10/589,091

Office Action Summary	Application No. 10/589,091	Applicant(s) SCHIERHORN, UWE	
	Examiner JONATHAN KOAGEL	Art Unit 3744

- 1) ☒ Responsive to communication(s) filed on 24 October 2011.
- 2a) ☒ This action is **FINAL**. 2b) ☐ This action is non-final.
- 3) ☐ An election was made by the applicant in response to a restriction requirement set forth during the interview on ____; the restriction requirement and election have been incorporated into this action.
- 4) ☐ Since this application is in condition for allowance except for formal matters, prosecution as to the merits is closed in accordance with the practice under *Ex parte Quayle*, 1935 C.D. 11, 453 O.G. 213.

Fig. 1

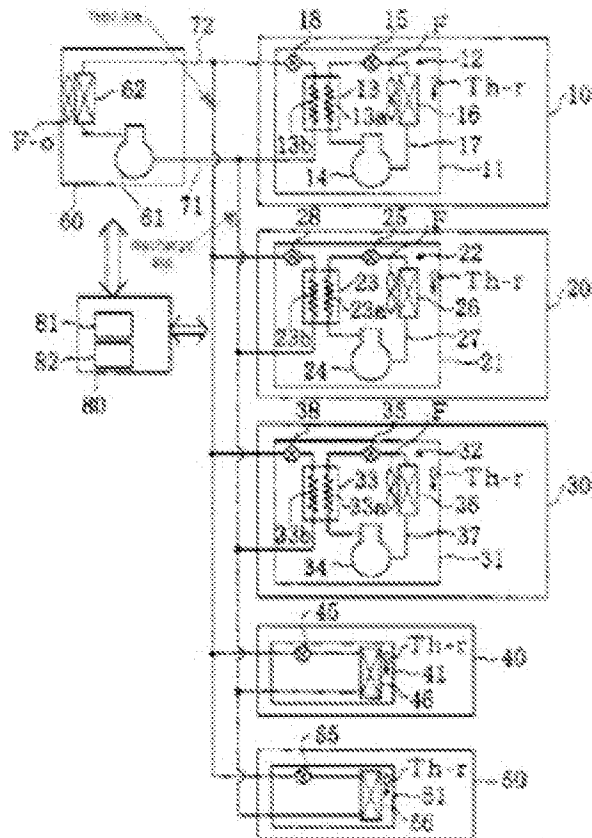
Regarding claim 14, Ueno teaches in fig. 1, a refrigeration installation having at least one refrigeration consumer 10, 20 which includes at least one evaporator 16, 26, having at least one feed line (See annotated figure below) and at least one discharge line (See annotated figure below), via which a refrigerant is fed to the at least one refrigeration consumer 10, 20 and discharged from the at least one refrigeration consumer 10, 20, the at least one refrigeration consumer 10, 20 having expansion members 15, 25, each said refrigeration consumer 10, 20 being assigned a linear compressor 14, 24. Ueno fails to explicitly teach the expansion members being designed as switchable expansion valves which are switchable between a first working position for normal refrigerating operation and a second working position for defrosting operation wherein, the refrigerant flowing through the expansion member is expanded when the expansion member is in the first working position and the pressure drop of the refrigerant flow passing through the expansion member is less than in the first working position when the expansion member is in the second working position.

Regarding claim 15, Ueno as modified above teaches the invention as disclosed and Ueno further teaches in fig. 1, wherein the at least one refrigeration consumer 10, 20 has a dedicated closed refrigerant cycle 12, 22, the refrigerant cycle 12, 22 being operatively connected via at least one liquefier 13, 23 to the at least one feed line and

the at least one discharge line, the refrigerant cycle 12, 22 in each case having expansion valves 15, 25 and linear compressors 14, 24, and the evaporator 16, 26 of said at least one refrigeration consumer 10, 20 in each case being arranged higher than the liquefier 13, 23 of the said at least one refrigeration consumer 10, 20 (column 4 lines 1-11, column 5 line 13-column 6 line 57). From a horizontal reference point of view in fig. 1 where a left direction is defined as a lower point and a right direction is defined as a higher point, the evaporator is arranged higher than the liquefier.

Regarding claim 19, Ueno as modified above teaches the invention as disclosed Ueno further teaches in fig. 1, a method for operating a refrigeration installation comprising providing a plurality of refrigeration consumers 10, 20, assigning at least one refrigeration consumer 10, 20 expansion members 15, 25 and linear compressors 14, 24. Utsumi teaches in fig. 2, during a defrosting phase of a refrigeration system, moving at least one of the expansion members 5 of the refrigeration system which is to be defrosted from the first working position into the second working position in which through-flow with a less pressure drop than in the first working position is possible (column 6 lines 3-15). Once Utsumi is combined with Ueno, the defrosting phase of at least one of the refrigeration consumers will occur by moving the expansion members of the consumers from the first working position into the second working position in which through-flow with a lower pressure drop than in the first working position would be possible.

Regarding claim 16, Ueno as modified above teaches the invention as disclosed and Ueno further teaches in fig. 1, wherein a plurality of refrigeration consumers 10, 20 are connected to the at least one feed line and the at least one discharge line. Ueno fails to explicitly teach the connection is by means of couplings.
